REMARKS

Serial No. 09/868,182

Attorney Docket No.: CELA:082

FIG 9

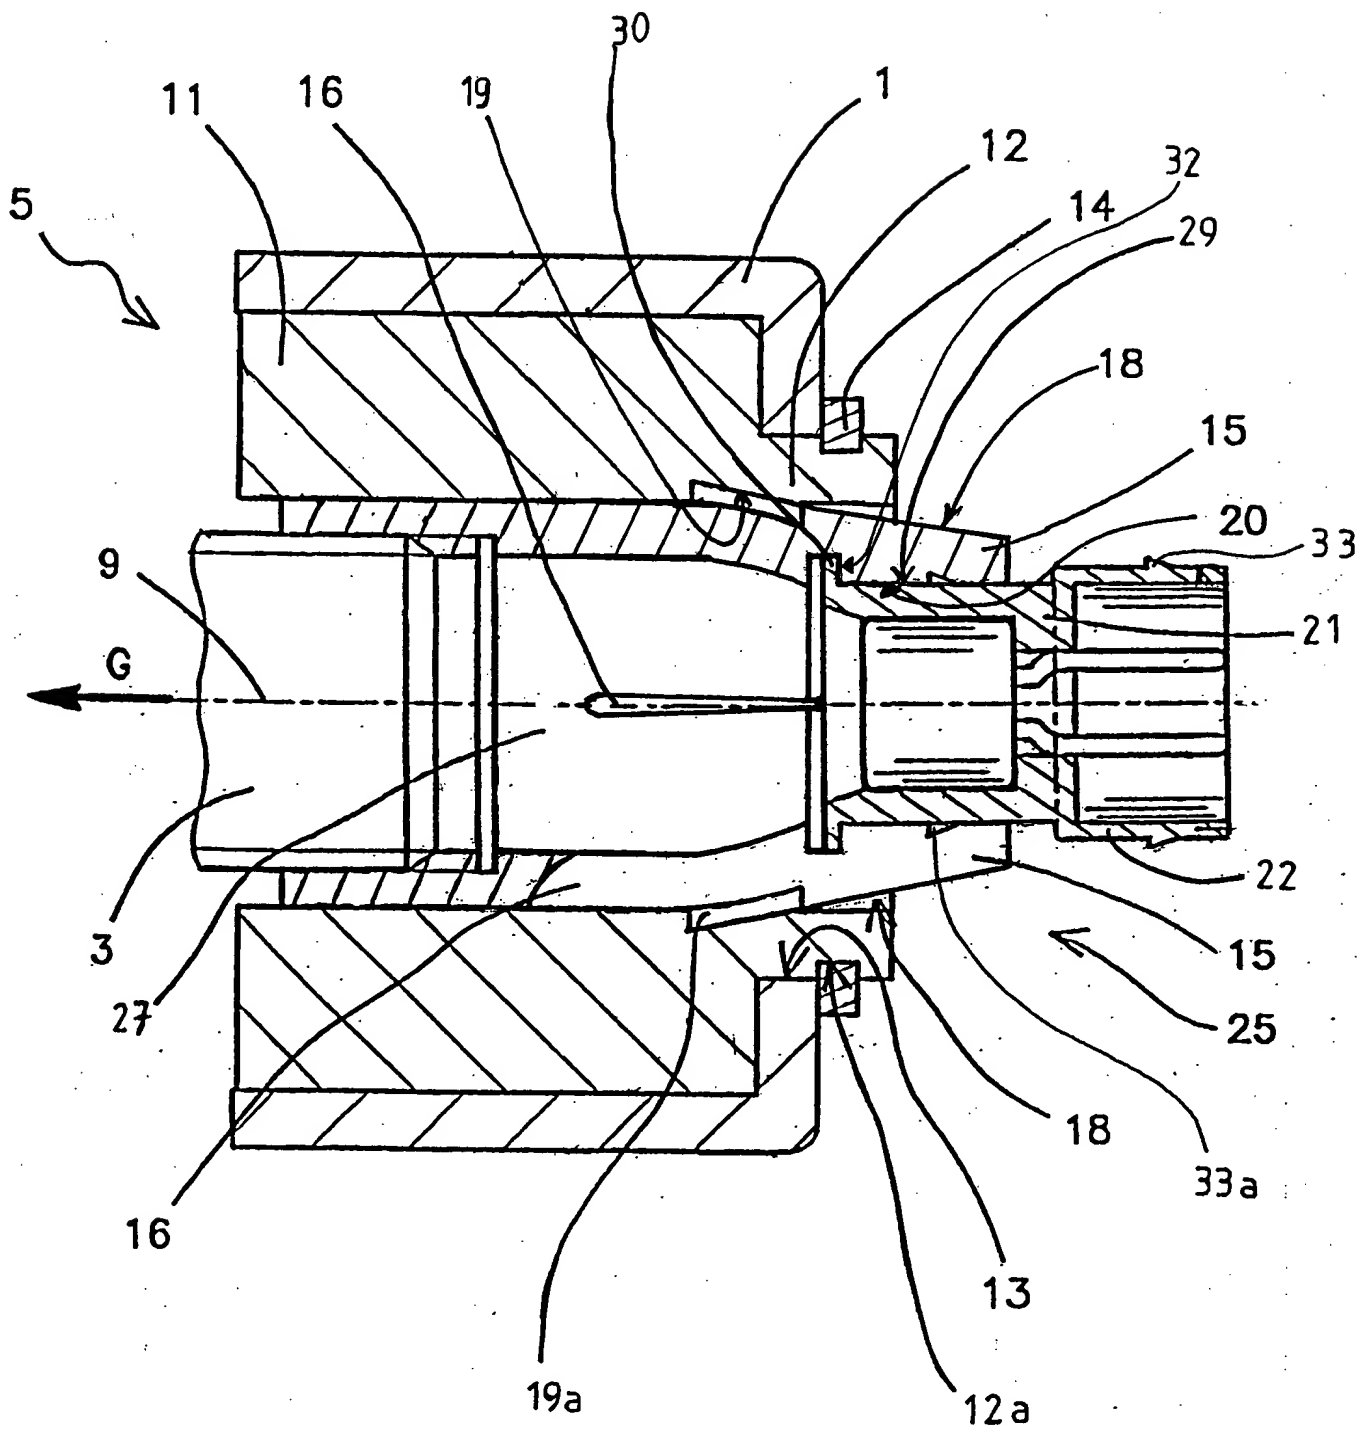
1. Section 3 of the Office Action contains an explanation why new Fig. 9 was not acceptable. Enclosed is a new Fig. 9 showing piston 21 displaced until collar 30 abuts against abutment surface 32, as mentioned by the Examiner. New Fig. 9 includes reference numeral 30 identifying the collar, reference numeral 32 identifying surface 32, and shows collar 30 abutting abutment surface 32 without a gap therebetween.

2. Section 4 of the Office Action recited objections to the original drawings. The items criticized in sections 3 and 4 are treated thusly:

A. New Fig. 9 shows piston 21 displaced until collar 30 abuts abutment surface 32.

B. Fig. 2 shows locking means 16 engaged with piston 21 at elements 33/33A, and new Fig. 9 shows element 33 in a disengaged position. Thus, Figs. 2 and 9 together show the locking means releasably engaged with the first external surface of the piston, as recited in claim 3. No change is required in Fig. 2.

C. Fig. 2 shows external profile 18 engaged with profile 19, and revised Fig. 9 shows profile 18 disengaged from profile 19. Thus, Figs. 2 and 9 together show the external profile 18, both engaged and disengaged from matching profile 19 of the matching second surface, as recited in claim 7. No change is required in Fig. 2.
